SERVICE BULLETIN

Title: VaporSaver Installation
Models Affected: 17/19 Series

Number: C9508
Date: 3/16/95
Supersedes: New
Date:

To advise that the outlet piping configuration of some VaporSavers may be incorrect.

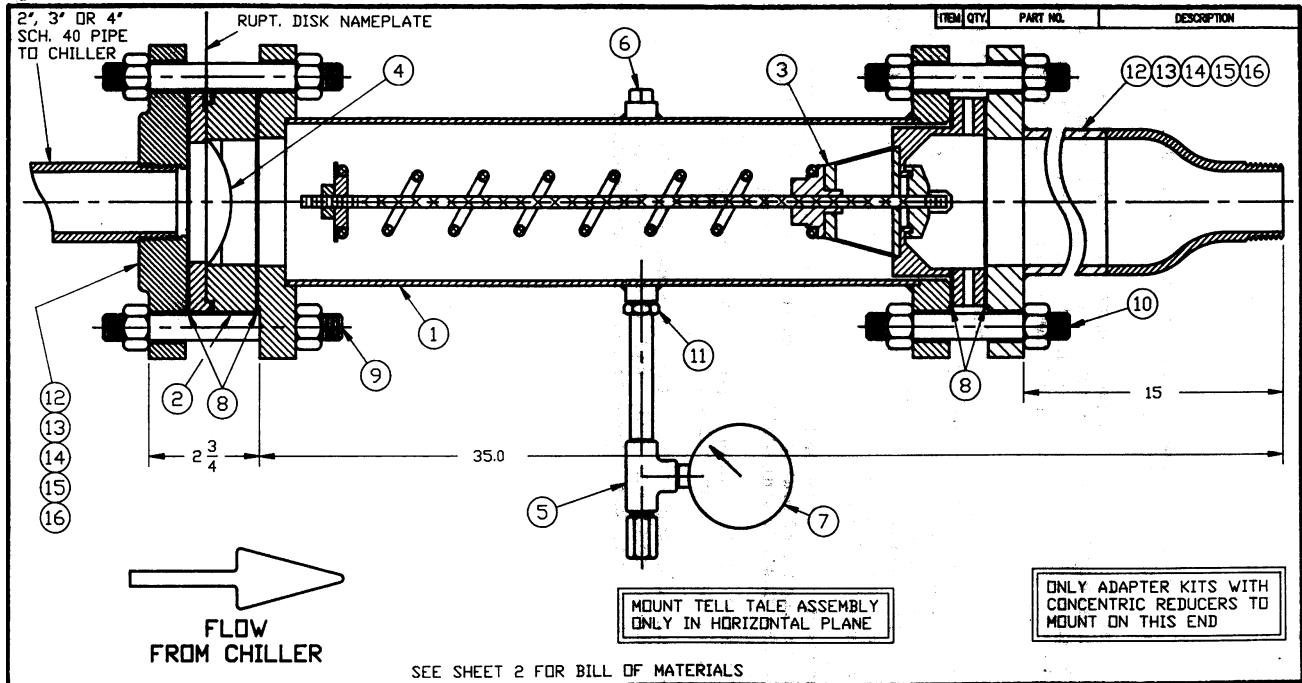
What has been happening is the inlet and outlet adapters are reversed. This places a threaded flange, (2" or 3") on the discharge of the relief valve. The small hole will not let the valve open fully, limiting the flow.

18. Install the 3/8" Pipe Plug, item 6, into remaining 3/8" NPT opening of the Flanged Canister, item 1, shell.
19. **Please note that the Outlet Flanged Adapter described in step 12 above, cannot mount directly to the chiller. The concentric reducer portion of the Outlet Flanged Adapter is designed to mount directly on the valve discharge via the flange portion of the adapter to allow proper functioning of the valve.**

Mounting the Outlet Flanged Adapter directly to the chiller will prevent the valve from functioning properly and void the warranty. The discharge from the Containment Unit must have a fifteen (15) inch long concentric reducer section to properly function in sizes 2" and 3". The 4" size unit may be discharged directly into 4" piping. All discharge piping must be

It is REQUIRED that a 4" section of pipe at least 13" in length be installed directly at the discharge of the relief valve, even if the vent pipe is less than 4".
